Declaration of changes from Initial to Variant

General: **4065F** is a variant product of **4065F**

Request for Class II Permissive Change

FCC ID: 2ACCJB156

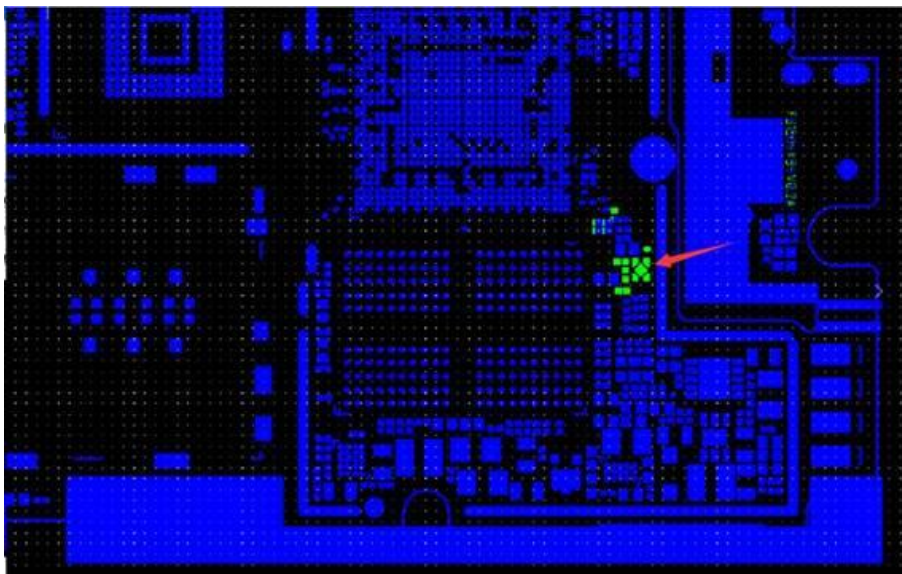
- Band changes: No
- PCB Layout changes: **Yes**

Add LDO for power supply to prevent fingerprint failure and brick problem
